14 January 2004

EnergyAustralia's response to PB Associates Final Report regarding revised estimates of transmission capex for 2004-2009 period.

Figure 1 – ACCC Sub-transmission Transformer Age Profile

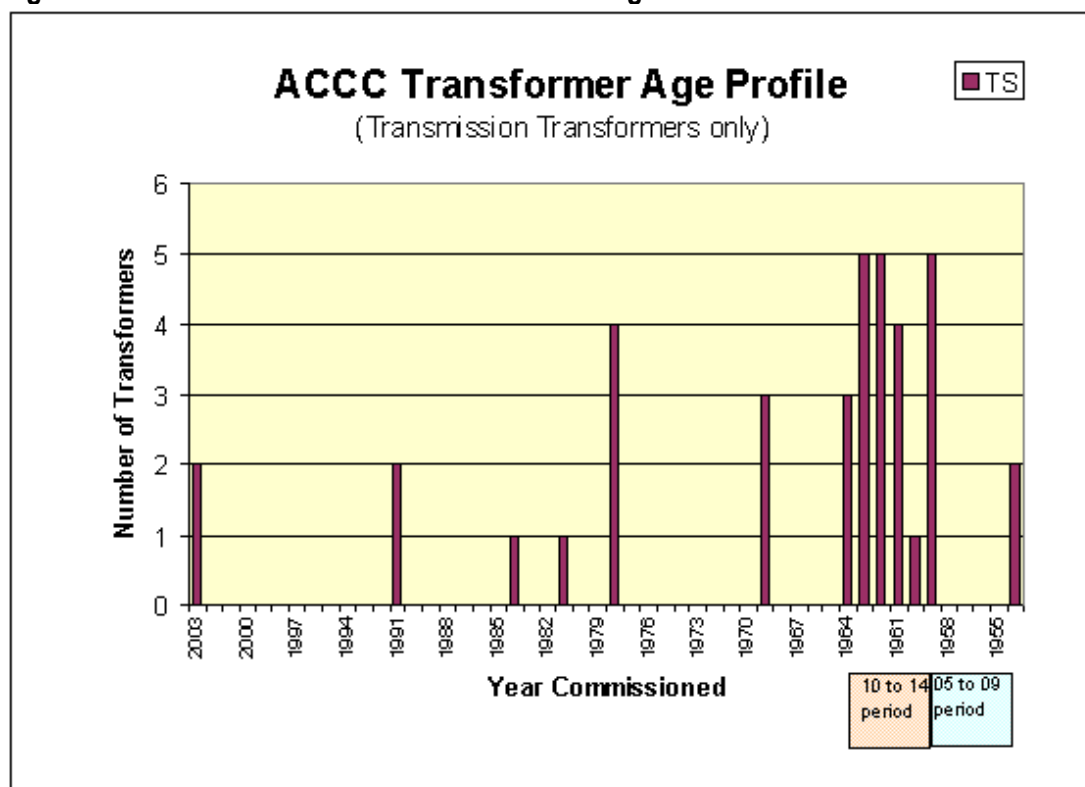
PB's recommendations for transformer replacement, if accepted by ACCC, will have significant implications for EnergyAustralia's network and the outcomes borne by EnergyAustralia's customers. For example, Figure 1 (next page) contains data which was included in the information provided to PB which shows that in the next regulatory period (2009-2014) there are more than 20 transformers that will reach their regulatory age limits. EnergyAustralia believes that it is impractical to replace over 20 sub-transmission transformers in a single regulatory period and in any case, many of these transformers have test results that indicate these units have reached the end of their regulatory lives. Therefore EnergyAustralia assessed the transformers with the poorest condition and prioritised their replacement in the 2004-2009 period. The replacement of the remaining, better performing transformers has been delayed.

If the ACCC does not allow the marginally early replacement of transformers in this period (2004-2009), EnergyAustralia's transmission network will be placed in the position of an unacceptable level of risk of equipment failure in the next regulatory period (2009-2014) as EnergyAustralia will be required to manage the replacement of **one third** of our ACCC transformer assets and the bulk of our sub-transmission transformers in a single period. This is an untenable scenario as the transmission assets are our most critical assets in terms of the performance of the EnergyAustralia network. Asset replacement experts within EnergyAustralia believe that to gain access to this many transformers in one 5 year period would lead to a deterioration in service outcomes for our customers.
